Staff Report

REPORT NO.: DSD-2024-182

SUBJECT: Minor Variance Application A2024-029 – 59 Vancamp Avenue

Figure 3: Proposed Site Plan

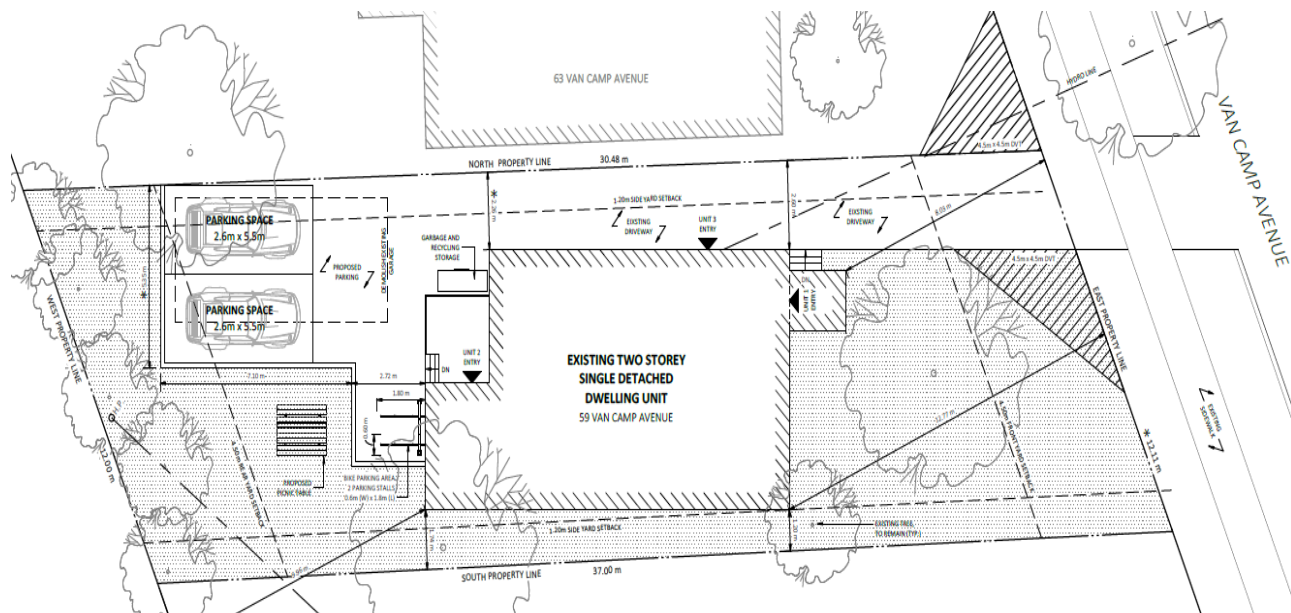
The applicant may need to give some consideration to the revised zoning regulations and may want/need to revise the proposed site plan accordingly; i.e. Unit Entry 3 will need to be relocated.

for door swing. For this application, the portion of the driveway that is 2.2 metres is a pinch point on the northwest building corner used for access to the parking area but not for parking vehicles in that space. The 2.2 metre width will allow for vehicles to pass through to access and does not need space for door swing as the vehicles will not be parked in the pinch point area.

The intent of the maximum driveway width of 40% of lot width is to preserve the streetscape for soft landscaping and ensure that driveways and paved areas for vehicle storage to not dominate the streetscape. For this application, the portion of the driveway that exceeds the maximum 40% regulation is in the rear of the site located behind the dwelling. The driveway location will be screened by the dwelling and will not have a significant impact on the streetscape.

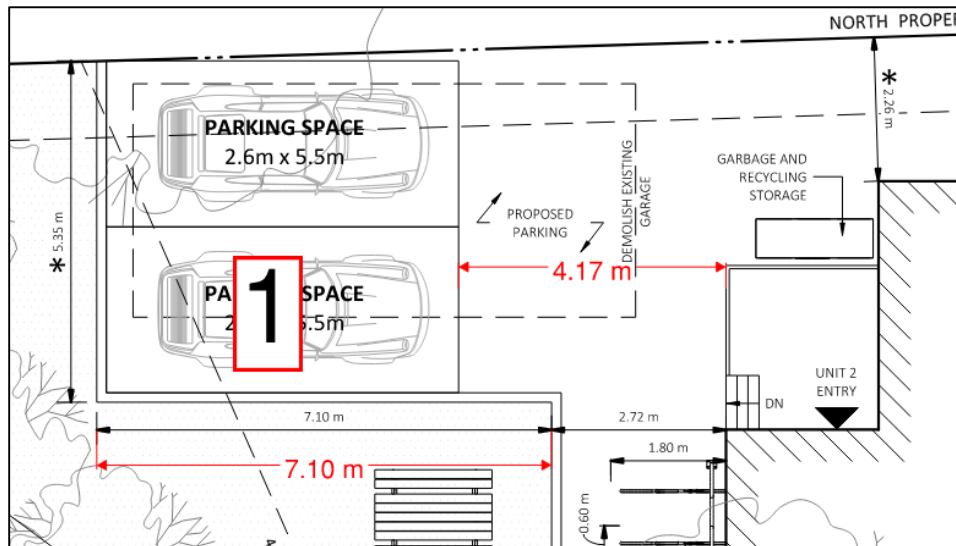
Transportation Services have no concerns with this application. However, we do want to show that accessing parking space “1” may be difficult at times due to the substandard drive aisle width of 4.17 metres. See illustration below. Also, potential tenants should be notified that there are only two parking spaces for three units.
